Scio Planning Commission – In Person & Electronic Meeting

1. *Public Hearing: PL2021-02* – Randy Nelson/Iceland Construction – Subdivision Re-plat 10S01W18AC, Tax Lot 0900
Presented by: Dave Kinney, Planning Consultant
2. *PL2021-03* – SMTA – Property Line Adjustment 10S01W18AD, Tax Lots 5100, 5200 and 5300
Presented by: Dave Kinney, Planning Consultant
3. Planning Commission Vacancy

SCIO PLANNING COMMISSION **STAFF REPORT**

COVER SHEET
TENTATIVE SUBDIVISION
10S-01W-18AC TAX LOT 900
Scio, Oregon

Sheet **C104**
SCALE: SEE BARSCALE

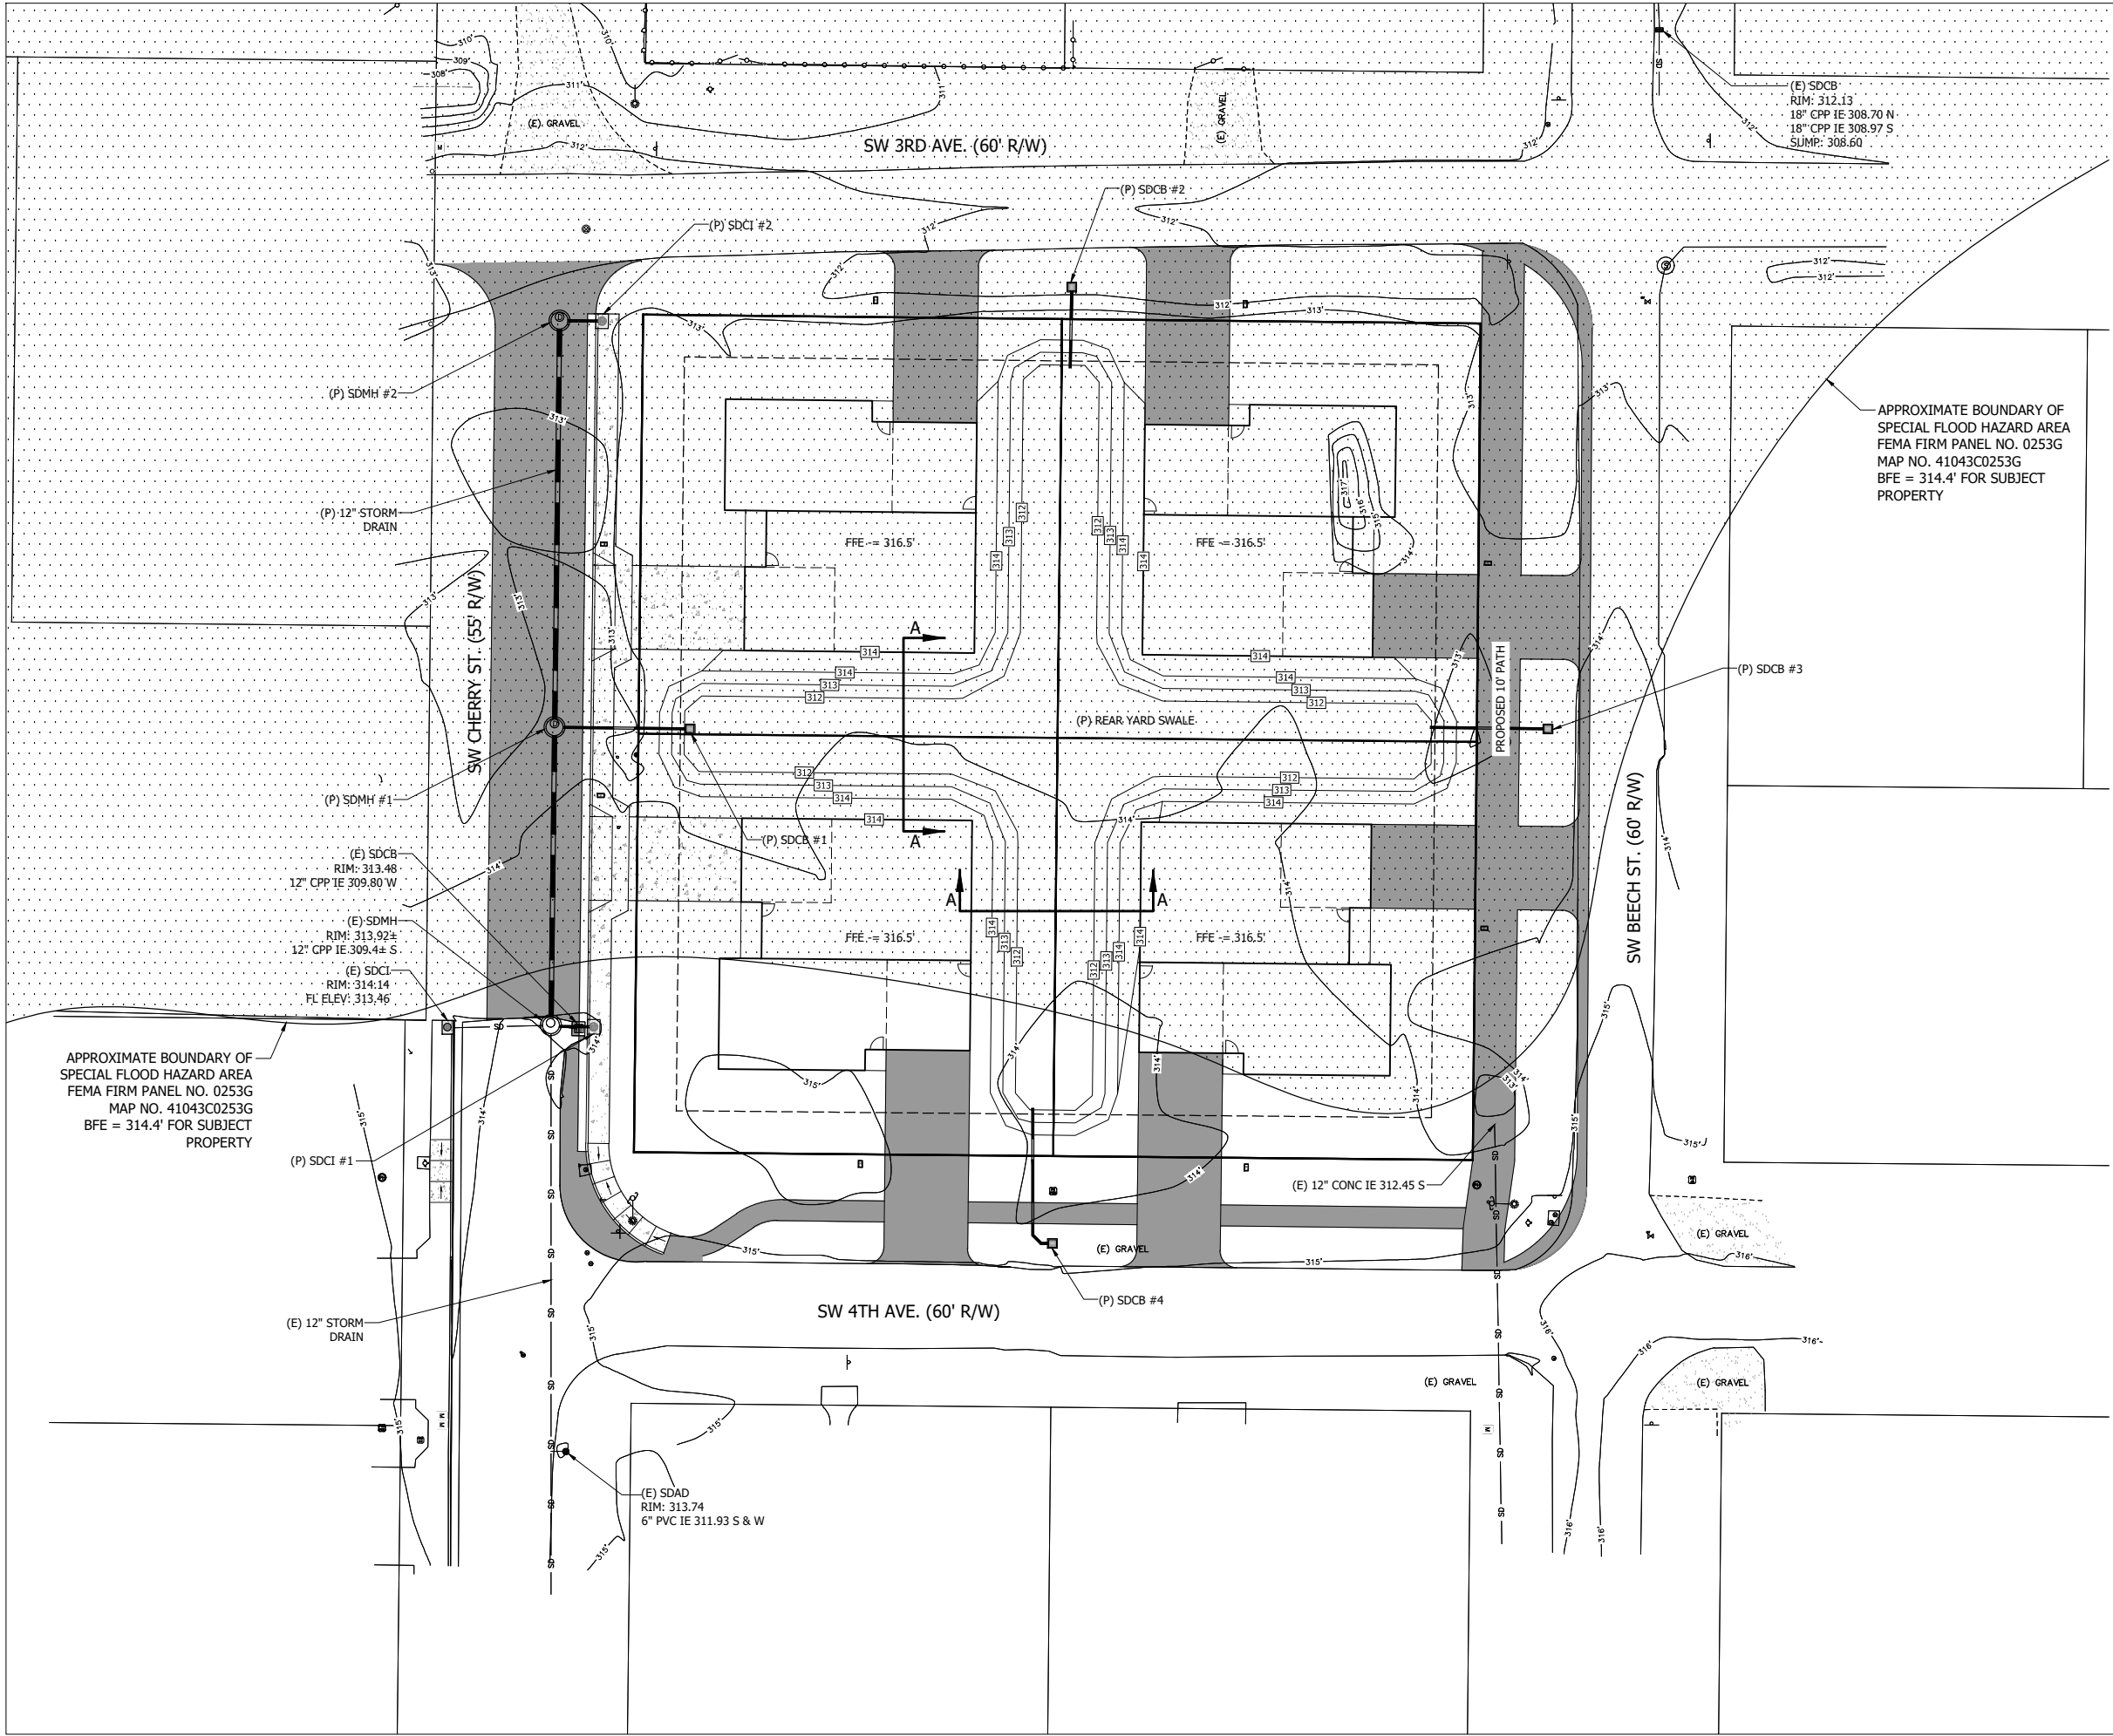
Sheet C104 shows water mains will be looped. A 6" water main will be extended on SW Cherry Street (SW 3rd to SW 4th) and water meters will be installed for all lots. If a subdivision is approved final engineering plans will be required to comply with the City public works standards.

Sheet C104 shows a sewer main extension and two sewer laterals on SW Cherry Street and two sewer lateral connections to an existing sewer main on SW Beech Street. If the subdivision is approved, the final engineering plans shall be submitted that comply with the City's public works design standards.

- P-6 SW Beech Street Sewer Line - Inflow & Infiltration Issue (I & I). City Engineer Ryan Quigley notes the SW Beech Street sewer main north to the City's pump station has I & I issues which may limit capacity and the # of new connections permitted. If the final plans show the SW Beech Street sewer main may be used, the City Engineer recommends I & I repairs occur concurrently with the project. If the SW Beech Street sewer main is overcapacity, then the applicant's engineer shall submit an alternate plan to connect to the SW Cherry Street sewer main.

- Final plans shall be submitted to the City Engineer and Oregon DEQ for approval.
- If the final sewer plans include sewer lateral connections from the SW Beech Street sewer main, the proposed improvements shall include improvements to reduce I & I into the SW Beech Street sewer main & Thomas Creek Pump Station.

14. Sewer Mains and Laterals: Design and construct the following sewer improvements:
 - a. SW Cherry St. Sewer Main Extension: An 8" sewer main extension and sewer laterals on SW Cherry Street (4th north to MH).
 - b. SW Beech St. Sewer Connections: Evaluate the condition of the SW Beech Street sewer main to determine if it may be used for the development. If the SW Beech Street sewer main can be used, submit final plans and recommendations for repairs/upgrades to reduce I & I flows and install sewer laterals on SW Beech St.

PRELIMINARY GRADING & DRAINAGE

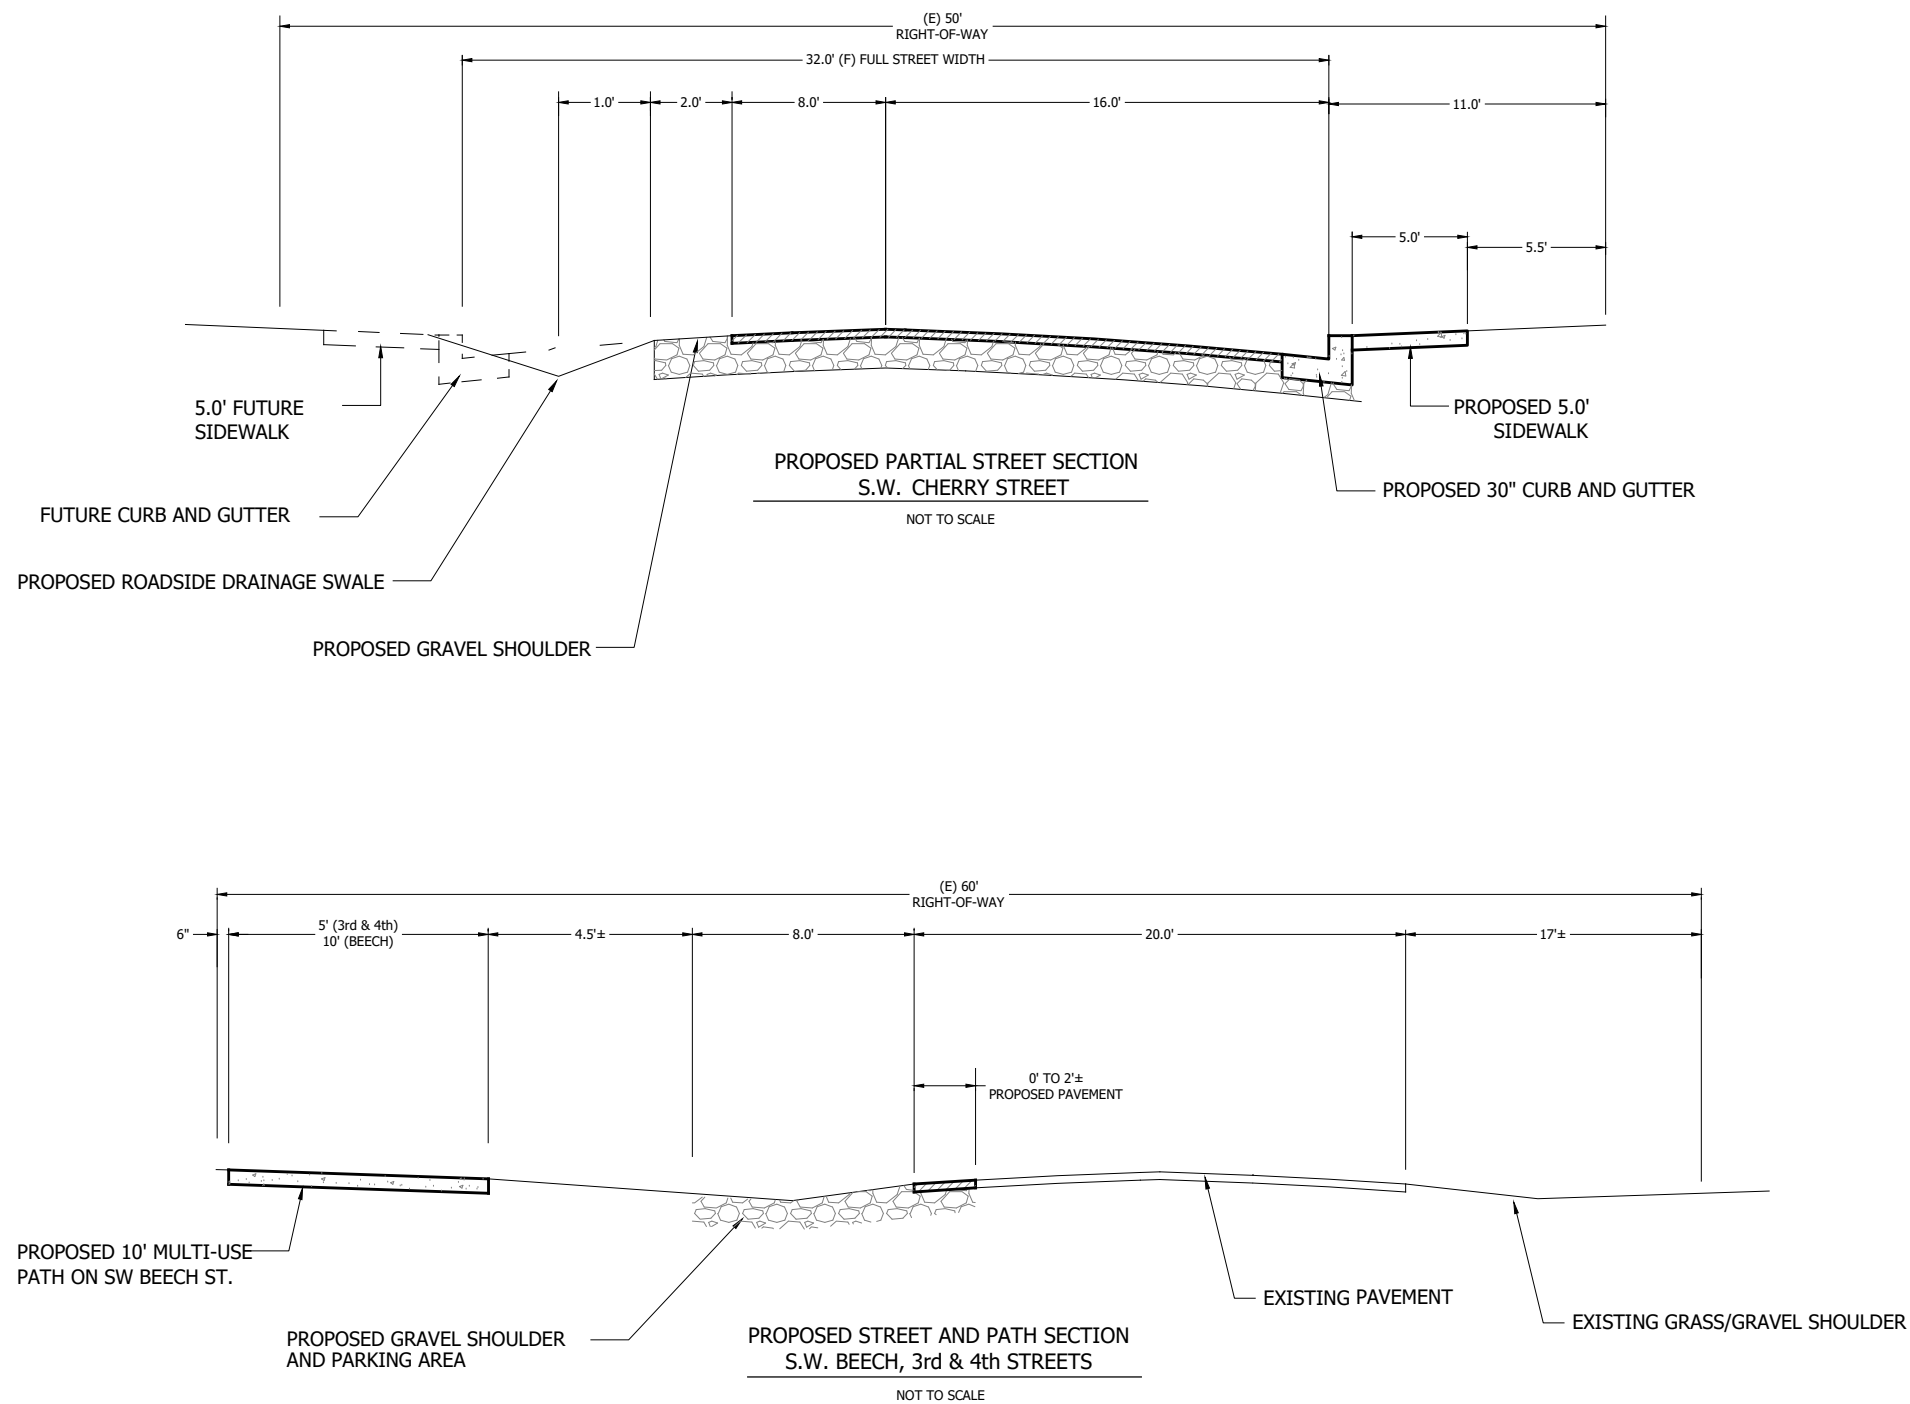
- NR-4 Sheet C105 of the applicant's submittal shows the approximate boundary of the 100-year flood plain, based on FEMA Firm Panel No. 0253G, Map No. 41043C0253G. All four lots are located within the 100-year flood hazard area. At the time a building permit is issued, the City requires a property owner to obtain a Flood Development Permit from the City and comply with National Flood Insurance Program (NFIP) regulations. Scio Ordinance 537 has a balanced cut & fill requirement to prevent development from causing an increase in flood depths.

- P-4 Storm Drainage. Sheets C105, C106 and C107 shows proposed on-site and off-site storm drainage facilities. Sheet C105 shows storm inlets on SW 3rd Avenue, SW Beech Street, rear yard drainage swales and connections to the existing storm sewer in SW Cherry Street.

Phys-1 Sheet C105 shows 80%+ of the site is located in the 100-year Flood Hazard Zone.

1. **Balanced Cut and Fill:** Final engineering plans and calculations shall be submitted to the City for review and approval by the City Engineer with calculations confirming the project is designed with a "balanced cut and fill" for the site.
2. **Flood Plain Development Permit:** Any applicant for a building permit shall obtain a flood development permit concurrently with the building permit. In lieu of a flood plain development permit, the applicant may provide evidence that FEMA has approved a Letter of Map Amendment (LOMA) removing the "building site" from the 100-year flood hazard area. Base floor elevations shall be 2' above the base flood elevation.

- Final plans and stormwater detention calculations shall be submitted to the City Engineer for approval.
- Final plans shall show a detailed fencing plan showing how functionality of the storm drainage facility will be maintained.
- The applicant will show the storm drainage easement to the City on the final plat.
- The applicant will prepare and record in the Linn County Deed Records a storm drainage easement/maintenance agreement:
 - granting the City the right to enter the property to perform maintenance and,
 - stipulating the storm drainage swale may not be filled in, and
 - stipulating fencing and improvements may not impede or inhibit the storm drainage function, and
 - stipulating the property owner(s) will be responsible for the on-going maintenance of the drainage swale on private property.

15. The applicant will submit a final storm drainage calculations and engineering plans for the storm drainage system, that are compatible with the required street improvements for the project. Plans will include a detailed fencing plan showing how functionality of the storm drainage facility will be maintained.
16. The applicant will prepare and record in the Linn County Deed Records a storm drainage easement/maintenance agreement:
 - granting the City of Scio the right to enter the property to perform maintenance and,
 - stipulating the storm drainage swale may not be filled in, and
 - stipulating fencing and improvements may not impede the storm drainage function or inhibit the system function, and
 - stipulating the property owner(s) will be responsible for the on-going maintenance of the drainage swale on the property.
